**North London  
Waste Authority**

**Ref: Consultation on the Proposed Submission North London Waste Plan**

### **Response 1**

Figure 7: Current Re-use and Recycling Centres (RRC) in North London p.26, Paragraph 9.32, p.73, Figure 6: Key Diagram, p.24 and Figure 9: Existing Waste Sites, p.33

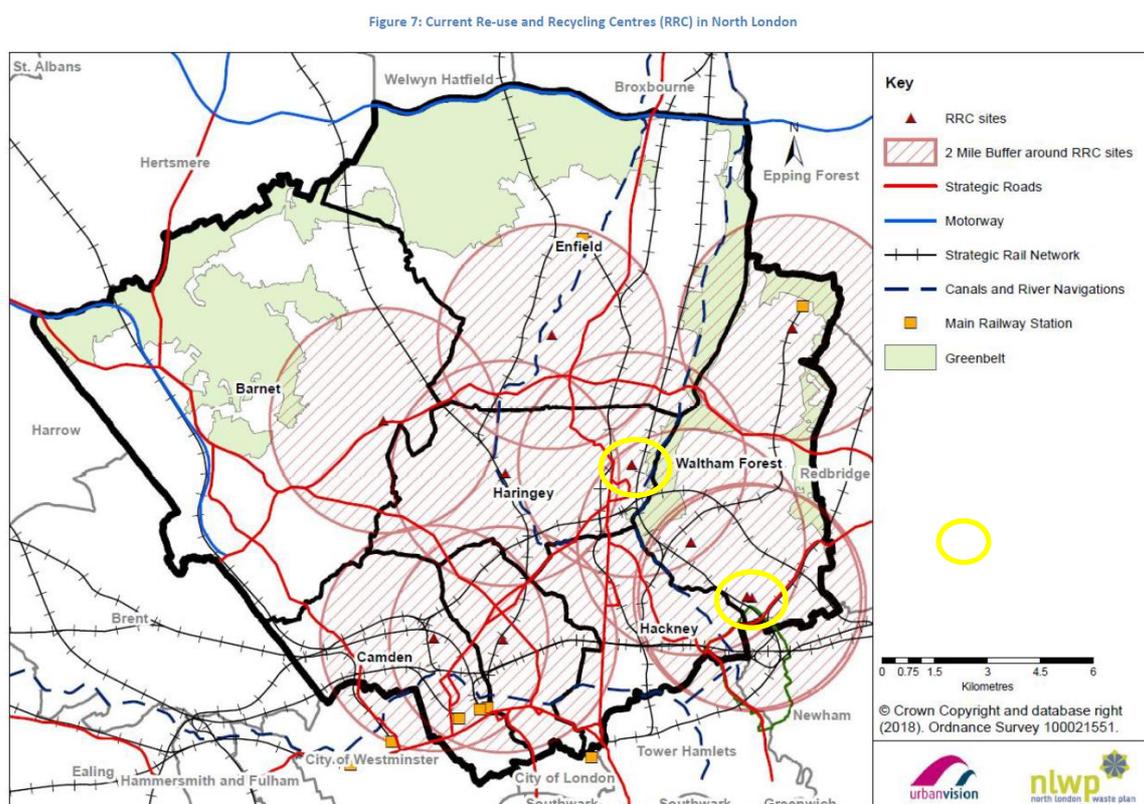
Figure 7 shows ten RRCs but there are only eight in operation, the following corrections should be made as marked up on the extracted image below:

- Two RRCs are illustrated in Haringey, the site shown to the east of the borough is the former Park View RRC which has closed.
- Two RRCs are shown at Gateway Road to the south of Waltham Forest. This site comprises an RRC and a separate depot operated by Bywaters, however the Bywaters site is not an RRC. Only one RRC should be illustrated at this location.

Related to this Paragraph 9.32 states: “There are currently nine RRCs in North London of which eight are the responsibility of the North London Waste Authority (NLWA)”. This should be corrected to “There are currently eight RRCs in North London of which seven are the responsibility of the North London Waste Authority (NLWA)”.

These corrections should also be translated onto Figure 9 which shows all existing waste sites including RRCs and Figure 6 Key Diagram.
